DUKE POWER COMPANY

January 2, 1985

Re: Catawba Nuclear Station
Docket Nos. 50-413 and 50-414

By letter dated December 17, 1984, Duke Power Company requested that the NRC Staff review and approve certain proposed changes to the post-fuel-loading initial test program as required by License Condition 3 of Facility Operating License NPF-31. Revised FSAR pages for the Reactor Coolant System Flow Test, Reactor Coolant System Flow Coastdown Test and the Pressurizer Functional Test were submitted along with the justification for the changes. As a result of further review of these items, the specific changes to Chapter 14 have been revised, but the thrust of the proposed changes has not been changed. The revised, marked up FSAR pages are attached.

FIGURE M6
REVISED

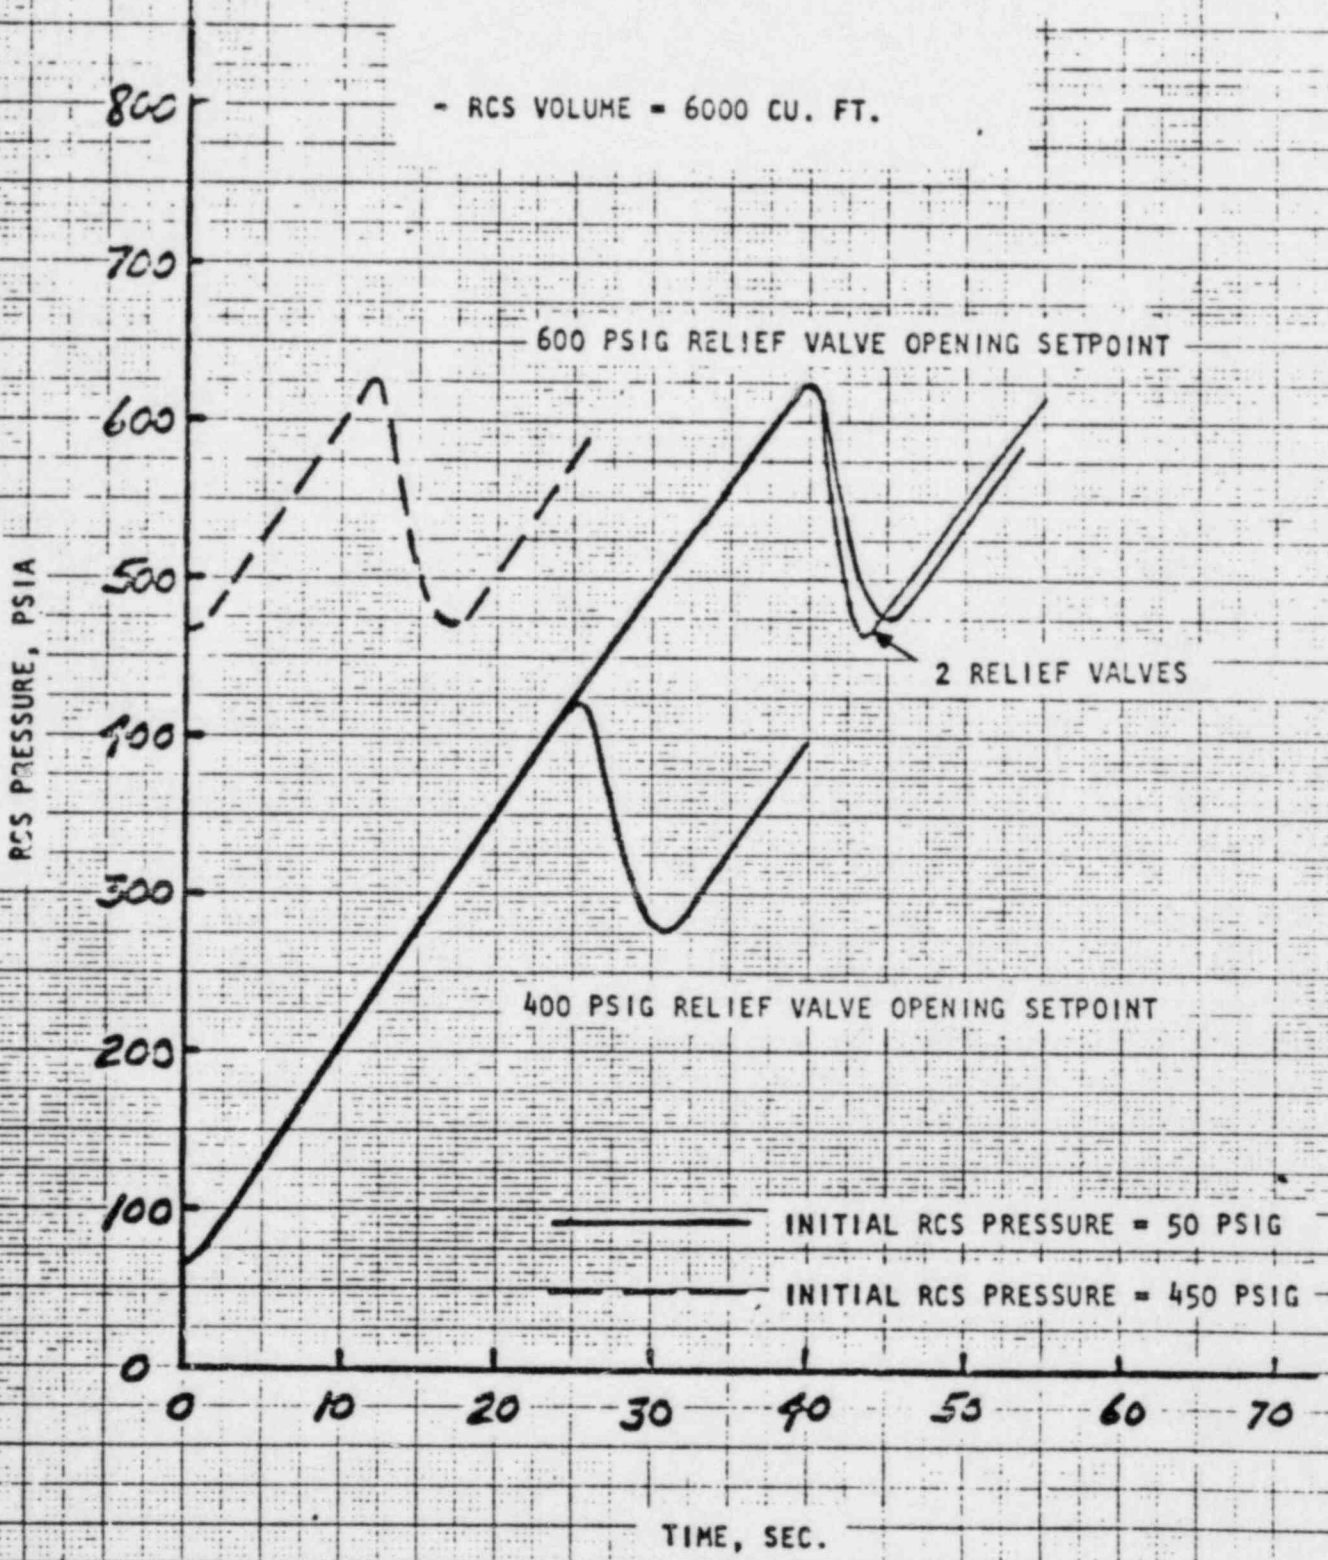
In both Figures M6 and M10, the common transient exhibiting RCS setpoint pressure undershoot response for two relief valve operation at a setpoint of 600 psig has been replotted to reflect valve closure at a reset pressure 20 psi below the setpoint. The original transient depicted in Figure M6 and Figure M10 of Reference 1 (Appendix B) represented valve closure at a reset pressure 120 psi below the 600 psig setpoint. As would be expected, the setpoint pressure under shoot has been significantly reduced to the extent that violation of the RCS pump seal pressure limit is no longer a consideration for this transient.
